**The Woodlands Off-Site Sanitary Lift Station, Force Main & Gravity Sewer Line A (RFCSP)**

**Solicitation Number: CO-00682**

**ADDENDUM 3**

**November 15, 2023**

SHEET NO.  
E-22

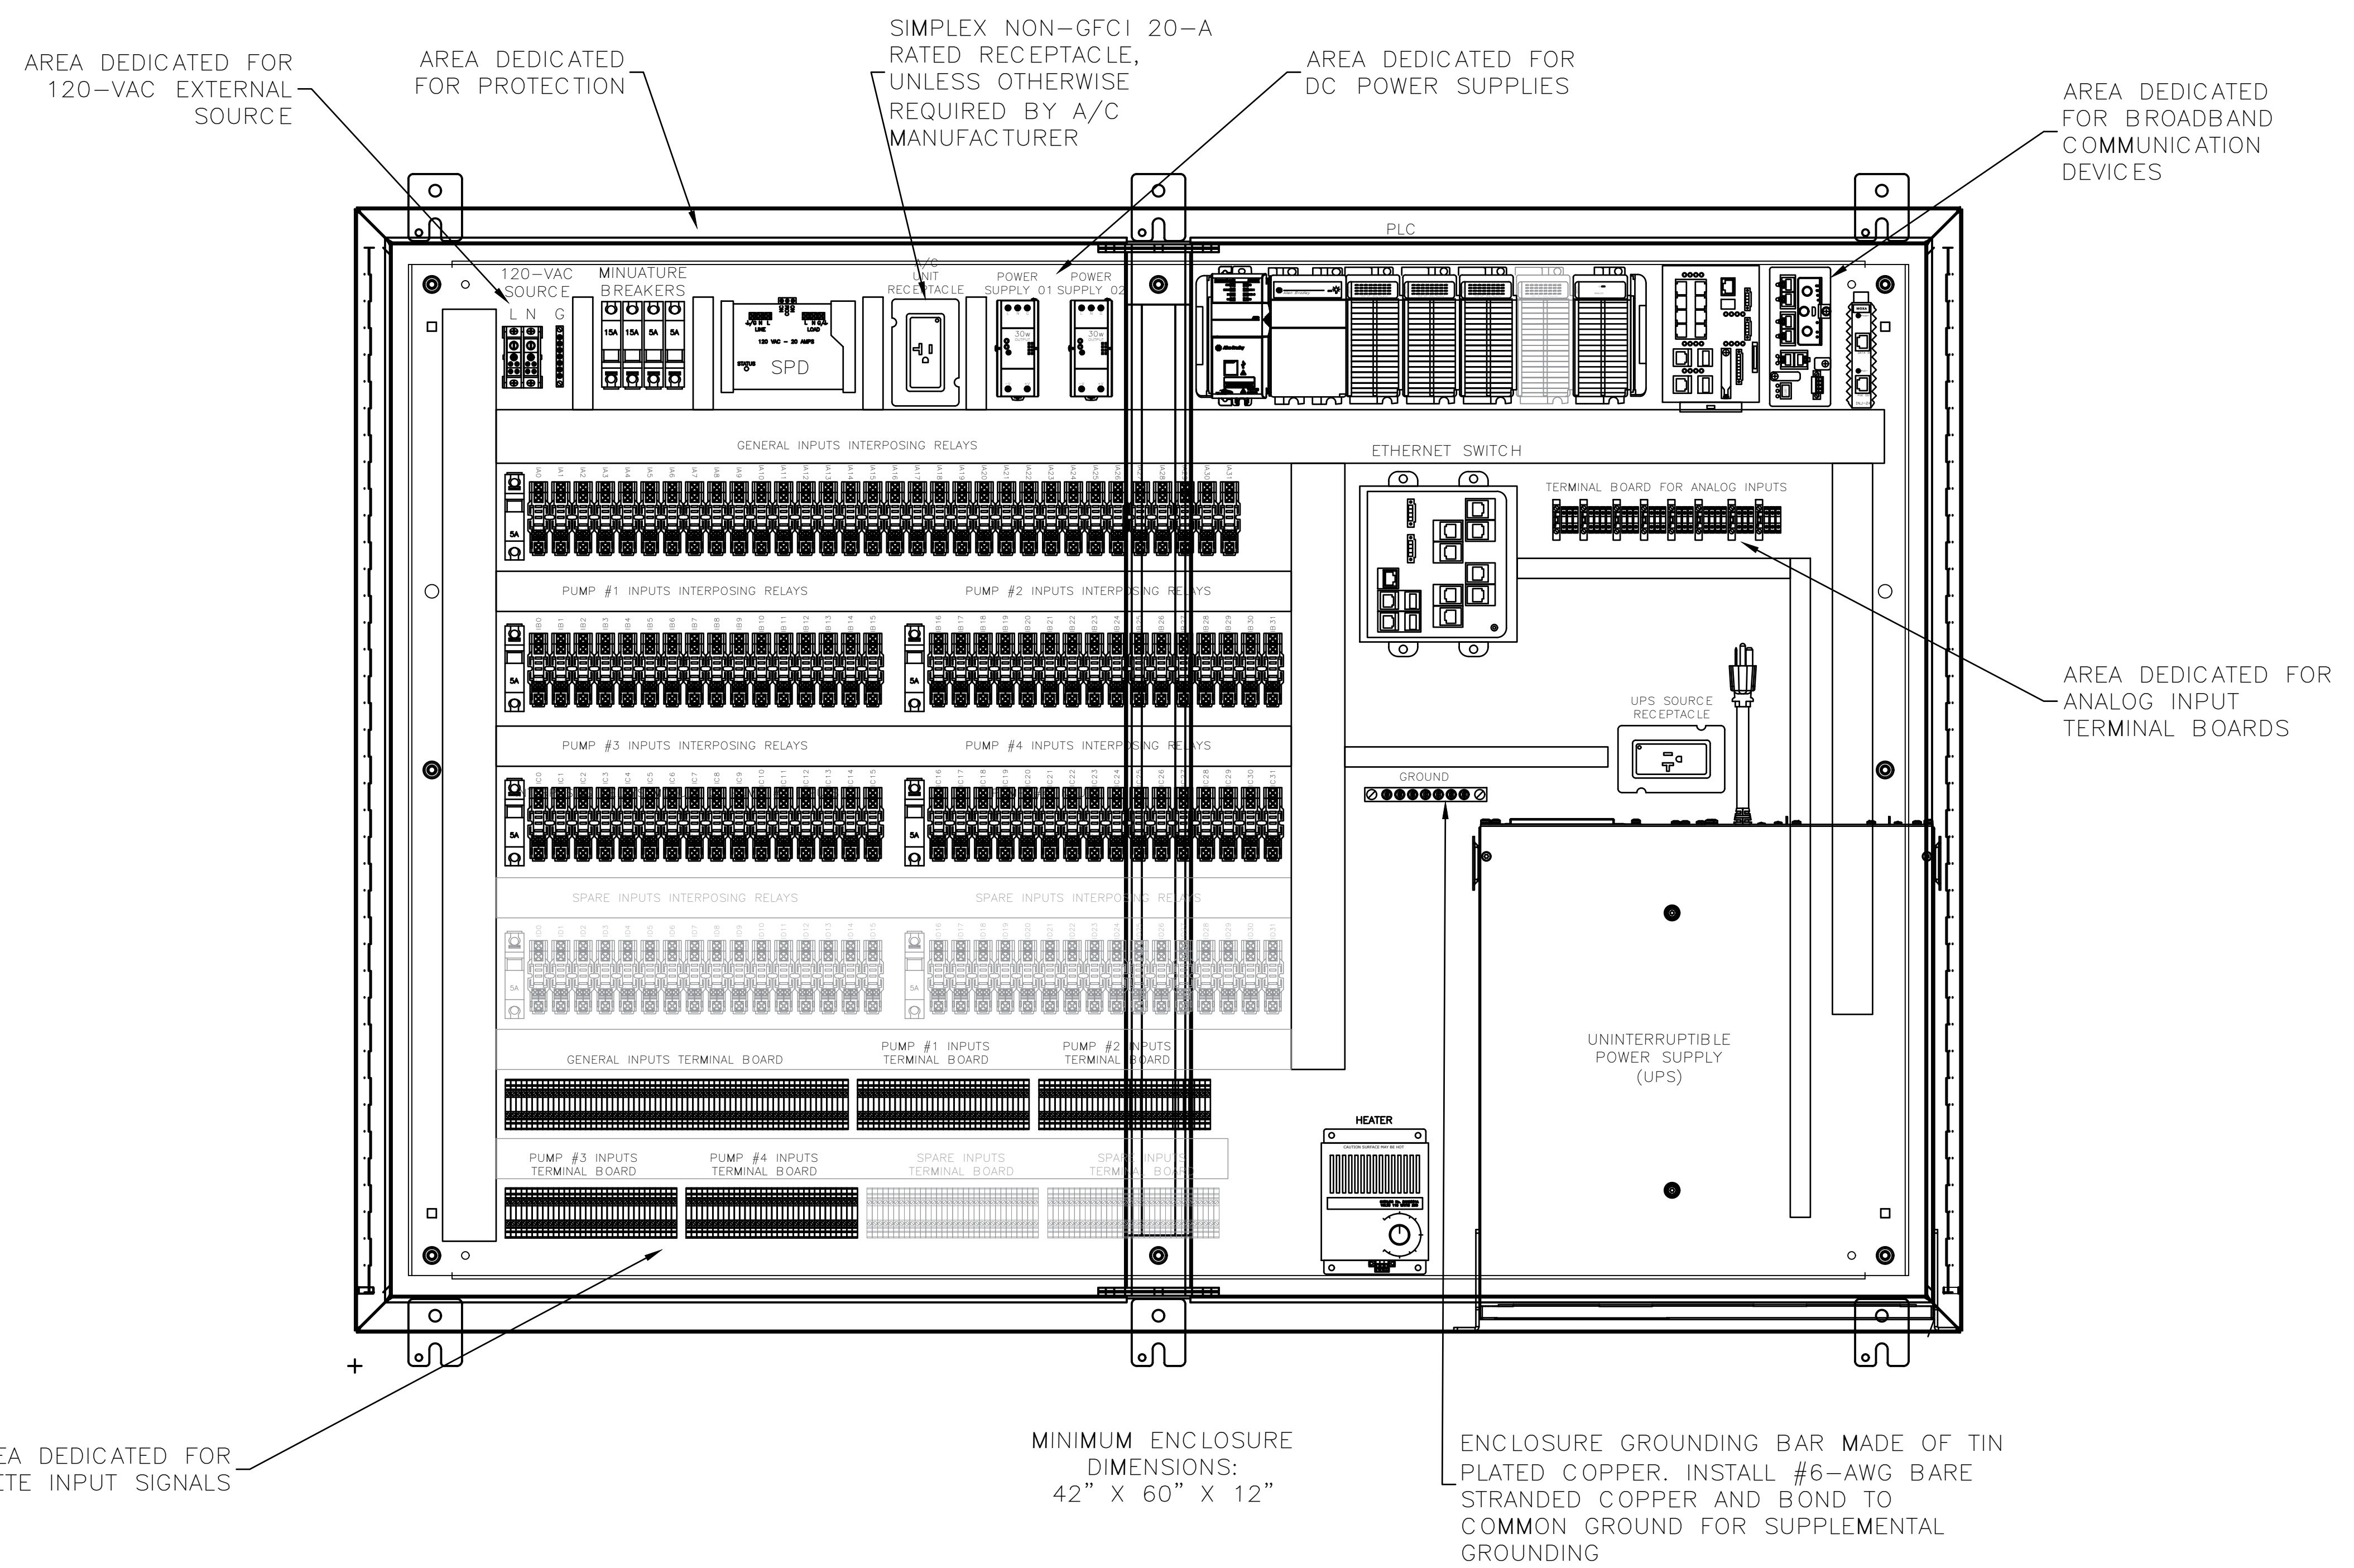
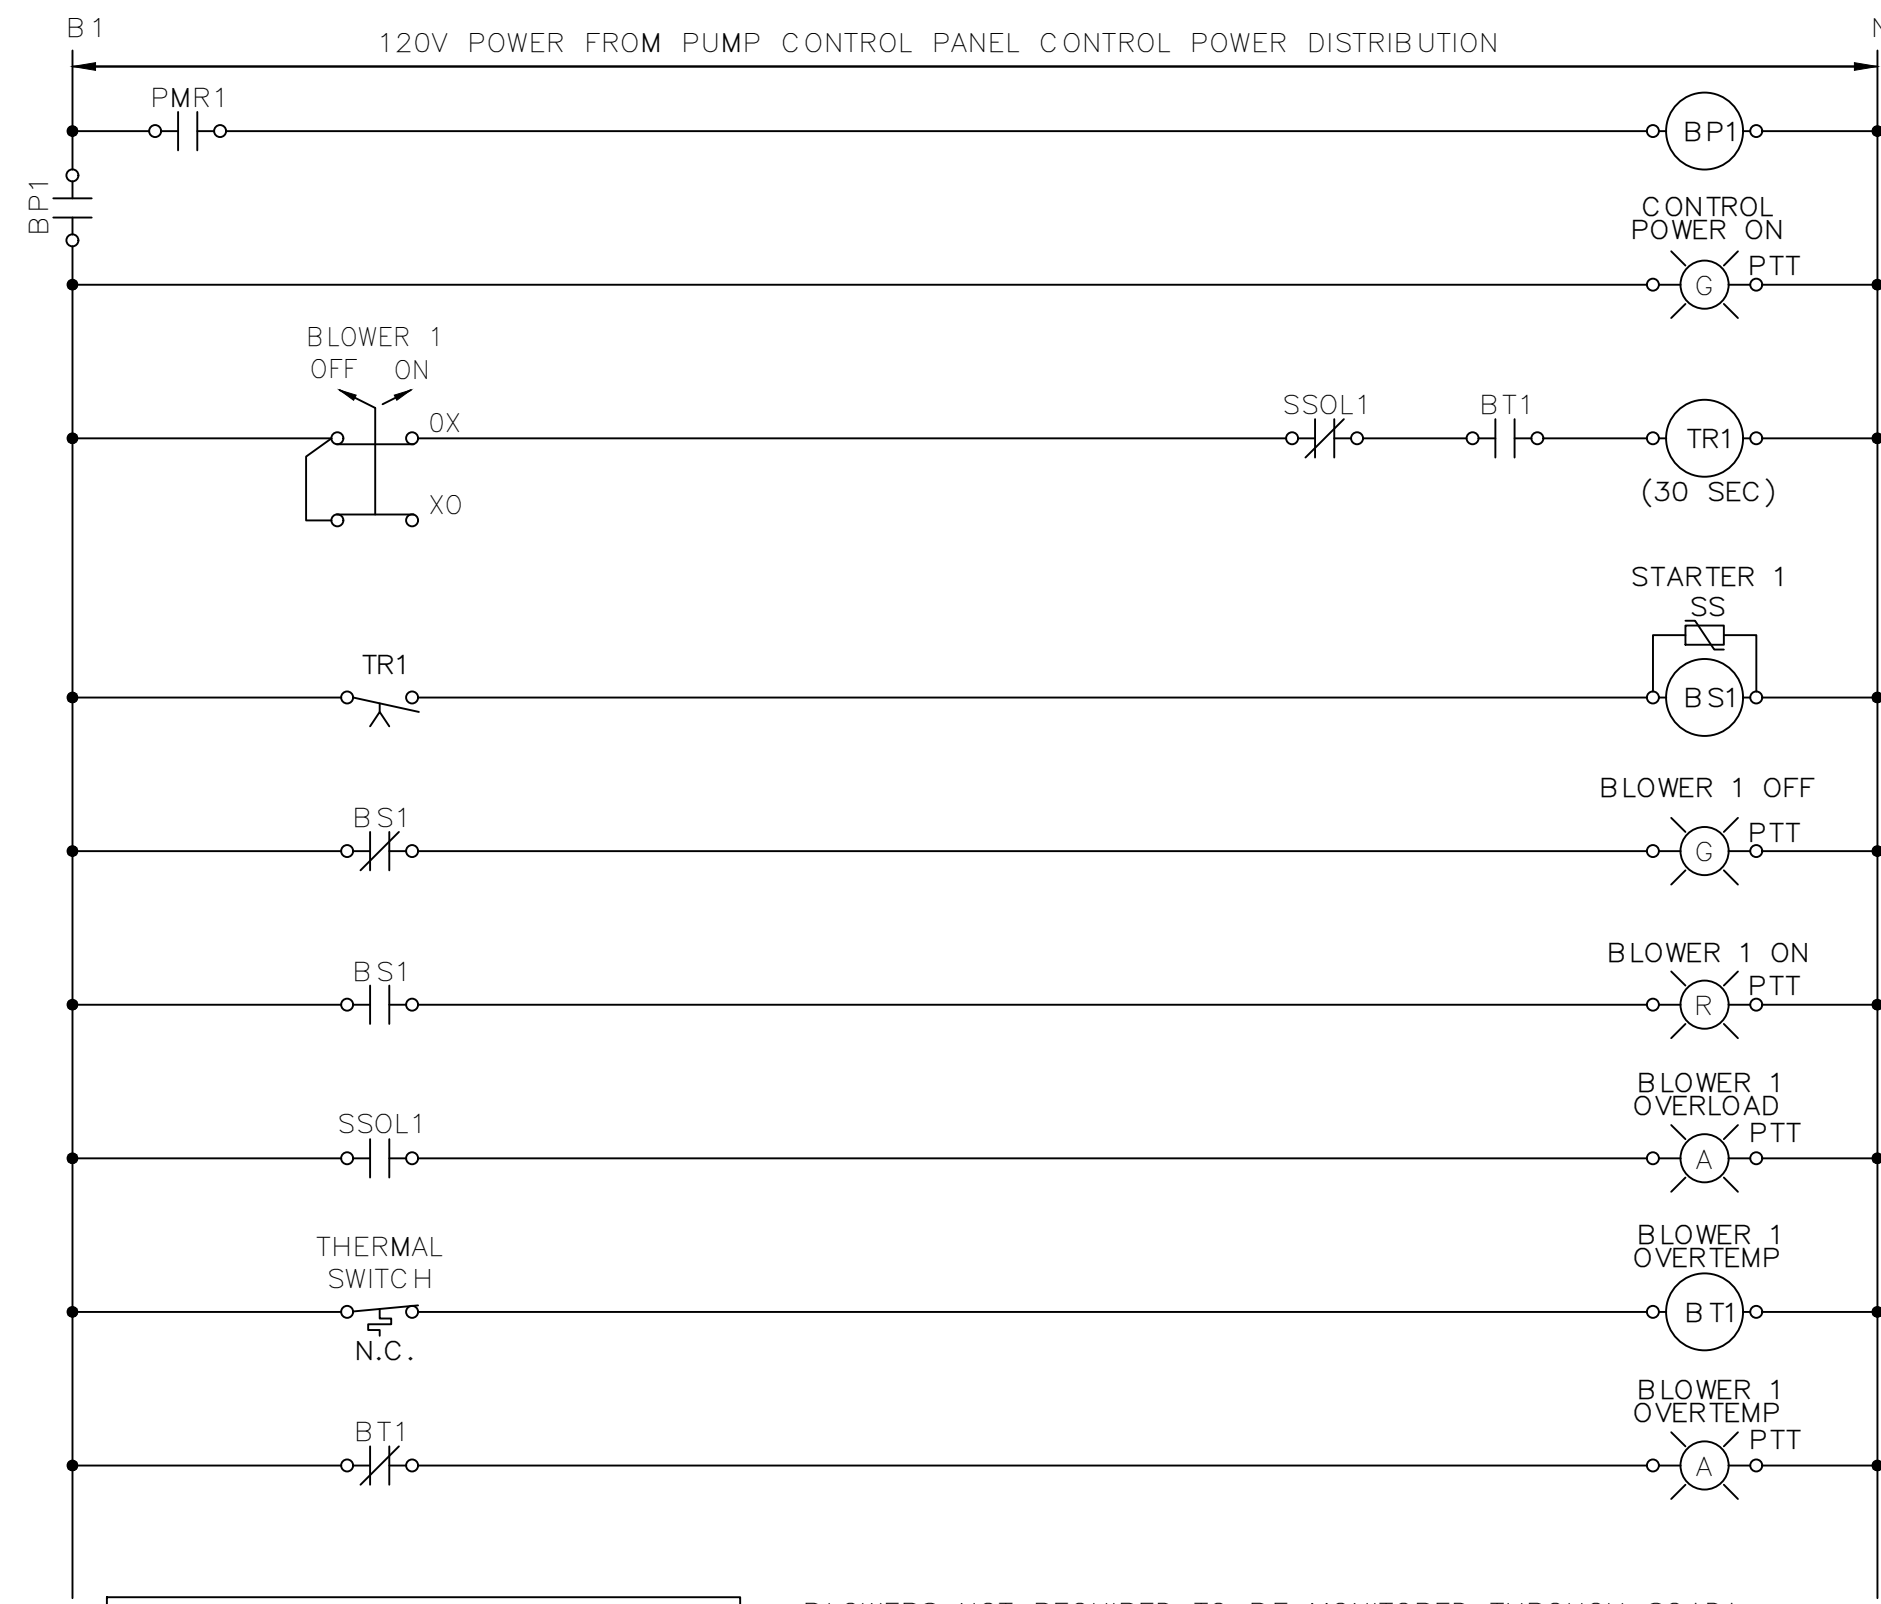
12. **Question:** On drawing E-4 keynote 9 it says the SCADA cabinet shall be a NEMA 12 wall mount enclosure. On drawing E-21 note 5 calls out for the enclosure to be NEMA 4X 316SS painted white. Which is correct?

**Answer:** *Since this will be installed indoors, NEMA 12 is acceptable. See Changes to the Plans #2. The previous sheet E-21 has been revised accordingly and re-issued as E-22 due to a previous duplication of sheet numbers.*
